PPPL ENGINEERING CHANGE NOTICE (ECN) ECN # 5145

COGNIZANT INDIVIDUAL: D. Williamson	
ECN TITLE: MCWF Type-B Modifications	
ASSOCIATED ECP: None	
CC/WP/Job:9450-1***-1403	AREA OR PROJECT: NCSX

DRAWING(S) AFFECTED NUMBER:	NEW Revision	TITLE
SE141-115	9	Production Winding Form Type-B

Type-B, Flange Datum -D, Coil Side -A

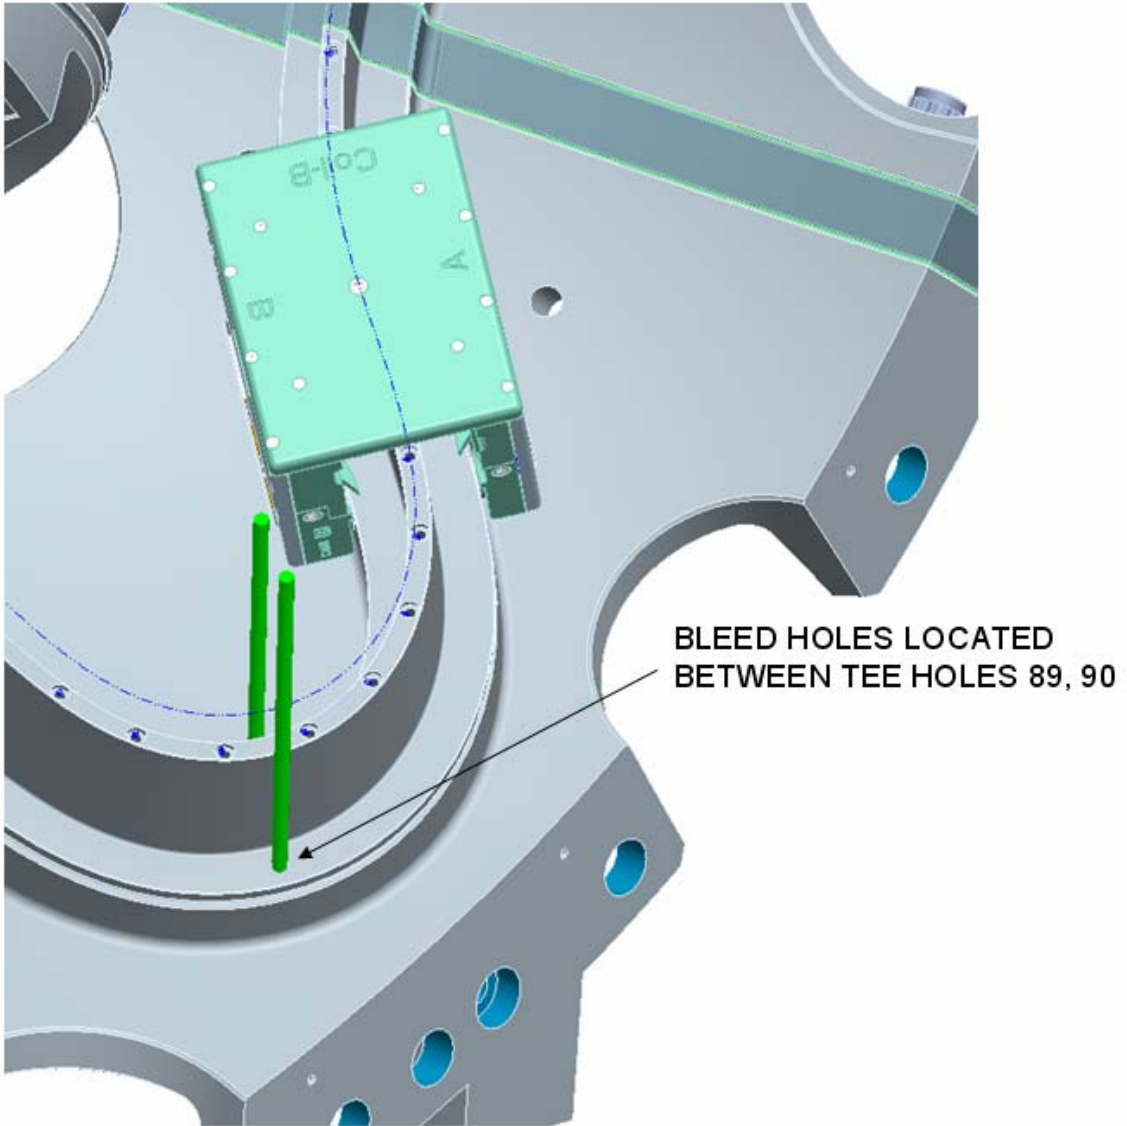
- 1) Change location of VPI bleed holes shown on SE141-115, Rev 8, Sht 9, D6.**
- 2) Revise tee tapped holes shown on SE141-115, Rev 8, Sht 2, B4 to show .75-in depth.**
- 3) Change 11 "counterbore only" tee holes, shown on SE141-115, Rev 8, Sht 2, C6, to no counterbore but add a mark indicating intersection of former hole axis with top of tee.**
- 4) Add requirement to note shown on SE141-115, Rev 8, Sht 7, E5, that mark be aligned with sections U2 and U3.**

Current location of bleed holes does not provide sufficient clearance with flange for fitting attachment. Upon review, it was decided to make holes adjacent to leads area so the leads can be positioned at the highest point during VPI operations.

Winding Form Inner Surface View

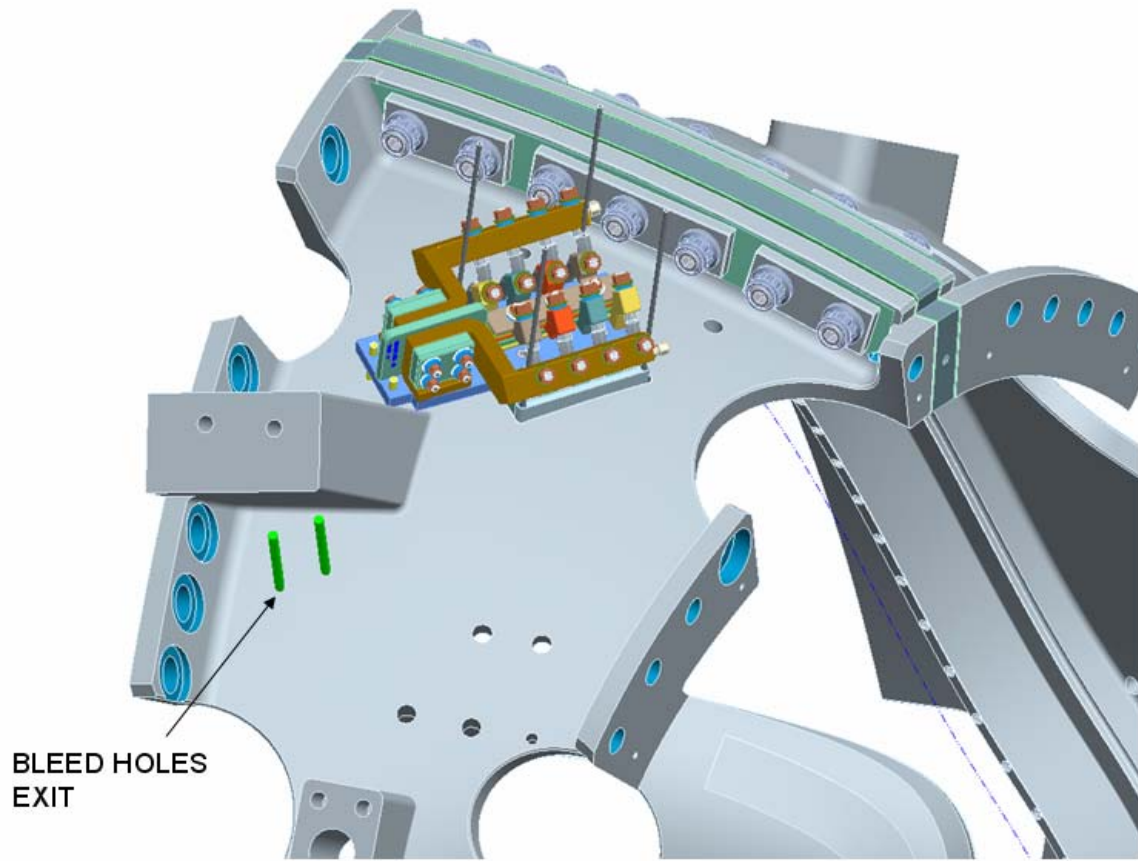
A counterbore complicates the installation of stud for winding clamp locations without a tapped hole.

Aligned mark aids in puck placement for lead blocks assembly.
